Historic Architectural Review Commission Staff Report for Item 5

Application Number: C2025-0062

Address: 704 Russell Lane

Request for postponement by staff - Demolition of non-historic carport and brick paving.

Map view of property showing existing carport proposed to be demolished.

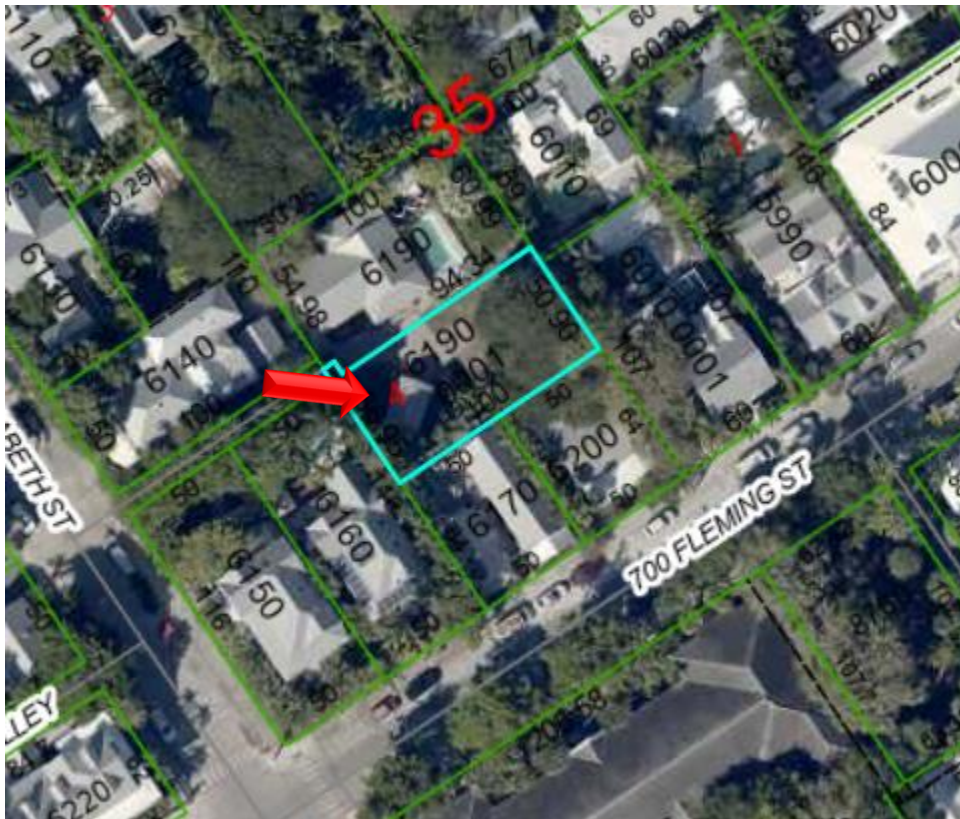
The Certificate of Appropriateness proposes the demolition of a non-historic existing carport and brick paving.

Since the carport under review is non-historic, the evaluation shall be based on section 102-218 (b) of the Land Development Regulations, which requires the following criteria for demolitions:

The carport structure is not historic and does not contribute to the character of the district or neighborhood.

The carport structure is not historic and does not destroy the historic relationship between buildings or structures and open space.

This will not be the case.

The carport structure is not historic. Staff opines that the structure would not qualify as contributing in the near future.

In conclusion, it is the staff's opinion that the request for demolition can be considered by the Commission as it meets the criteria for demolition stated under the Land Development Regulations. If the Commission finds the design appropriate this will be the only required reading for demolition.
